DECISION No 17/2022
OF THE EUROPEAN UNION AGENCY
FOR THE COOPERATION OF ENERGY REGULATORS
of 26 October 2022

**on Svenska kraftnät's request for a derogation from the 70% requirement
pursuant to Article 16(9) of Regulation (EU) 2019/943**

Figure 2 Levels of MACZT [%] (top) and unavailability of production [MW] in Ringhals and Oskarshamn nuclear power plants (bottom): Mar-Dec 2021

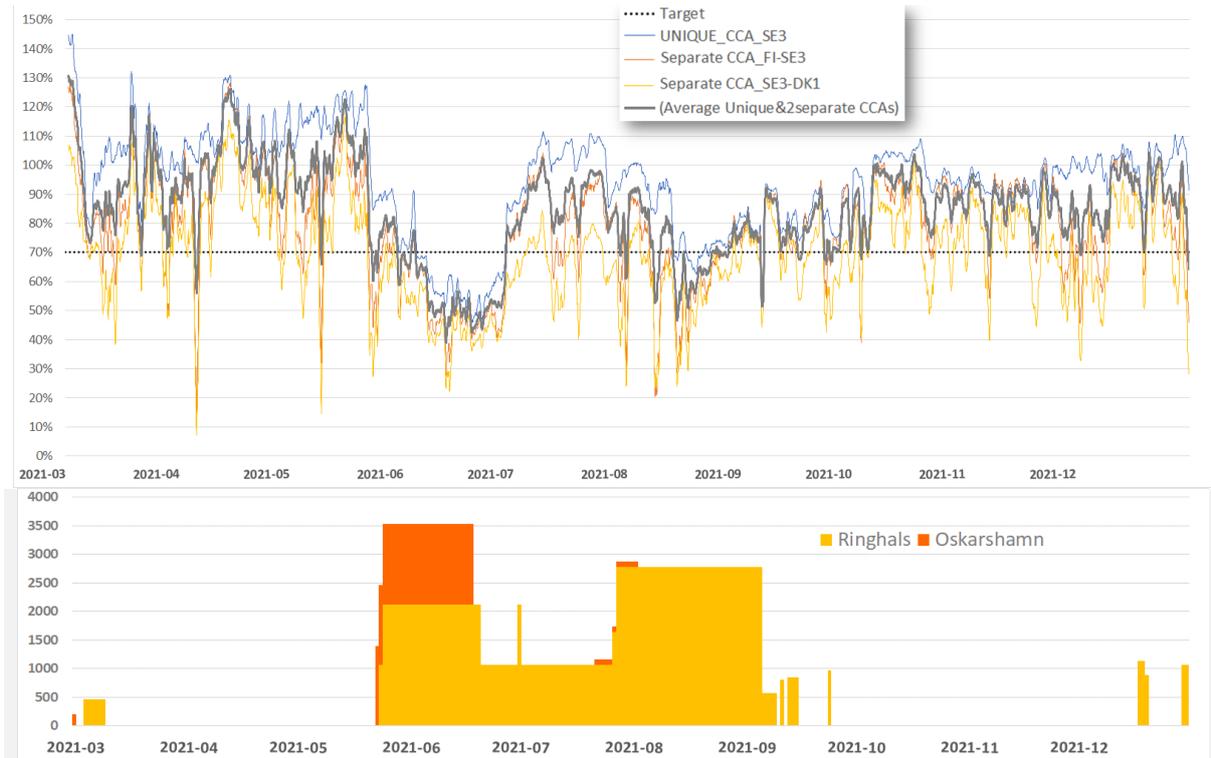
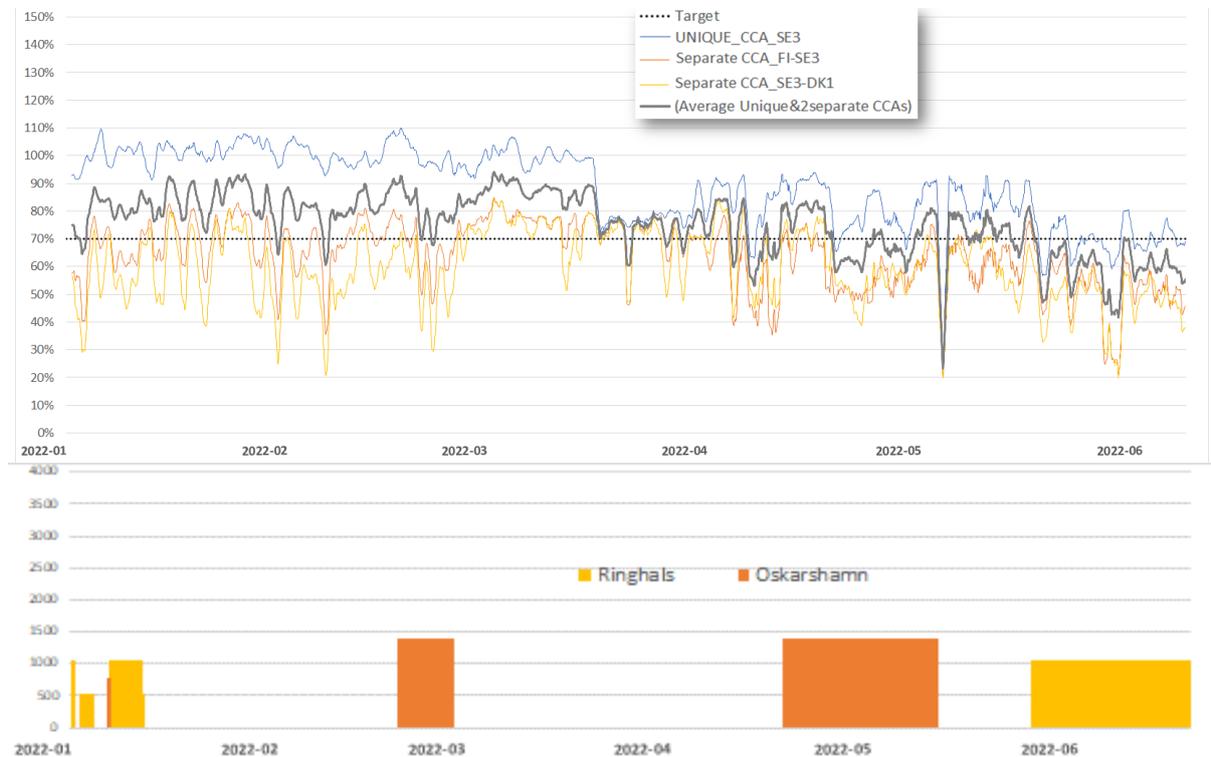
- (102) The main time periods with lower MACZT (30 May to 28 June 2021, 13 August to 23 August 2021, 17 May to 6 June 2022) seem to be partly linked to the unavailability of the Ringhals and Oskarshamn nuclear power plant units.

- (103) Nonetheless, the unavailability of the nuclear power plants cannot be the sole reason for explaining Svk's levels of MACZT, as some temporary decreases in these levels (e.g. in 2022) did not relate to the outages. In addition, it appears from this analysis that any outages below 2000 MW do not notably affect the Svk's levels of MACZT.
